Qualification of an alternative emitter chip for linear coupler family

Product Change Notification

Product Group: OPT/Tuesday April 8, 2025/PCN-OPT-1378-2025-REV-0

Slide 6

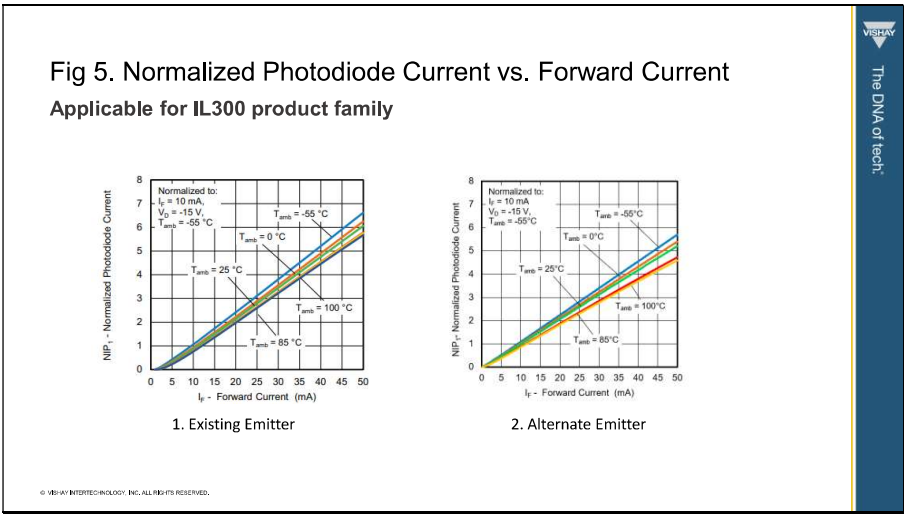
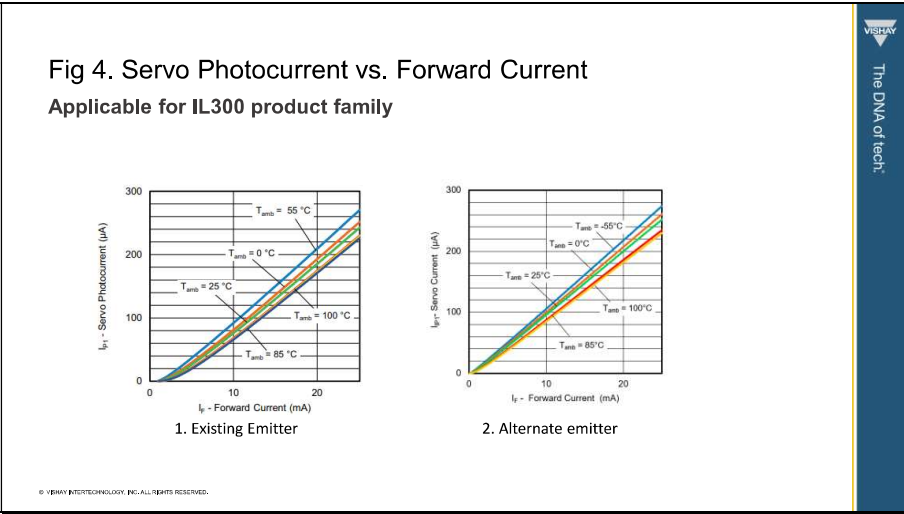
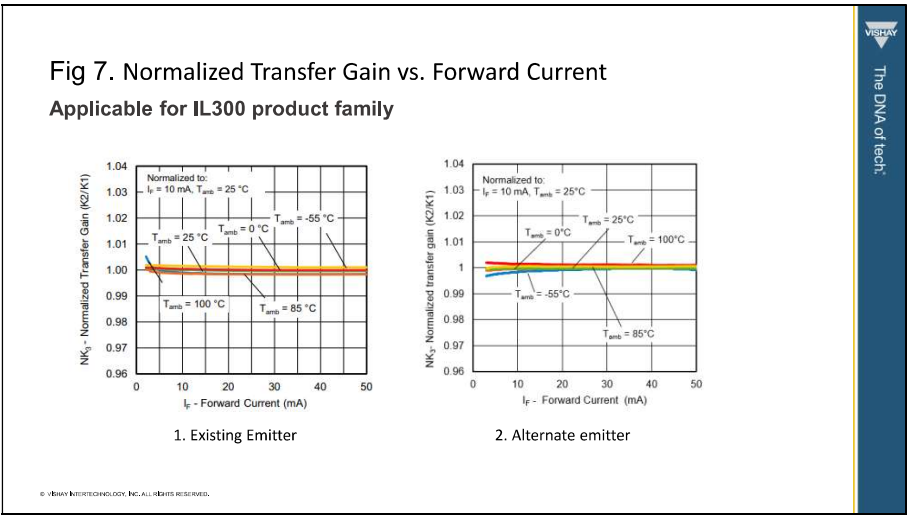
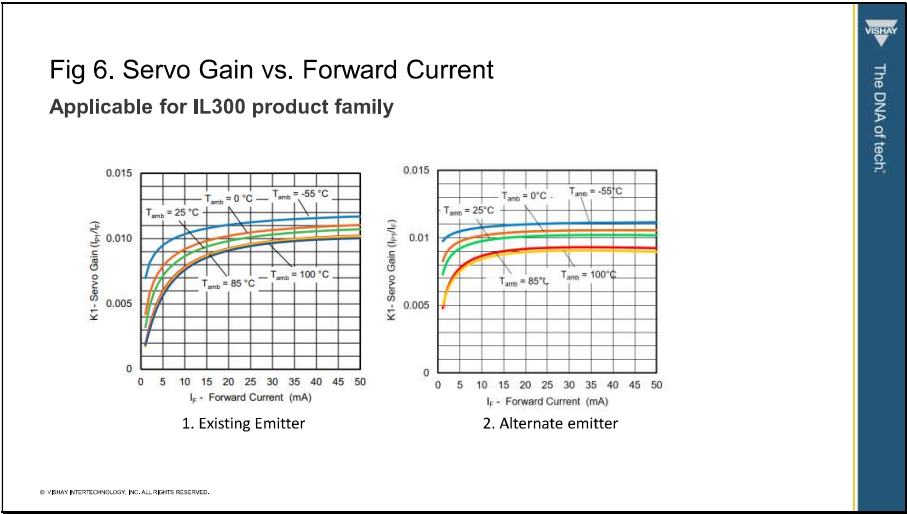
Note: The comparison data shows differences in the typical curves of the affected parts when using an existing emitter or an alternative emitter. Since the specifications in the datasheet remain unchanged due to the qualification of an alternative emitter the datasheet with Rev. 2.6, 20-Jun-2024 remains valid.
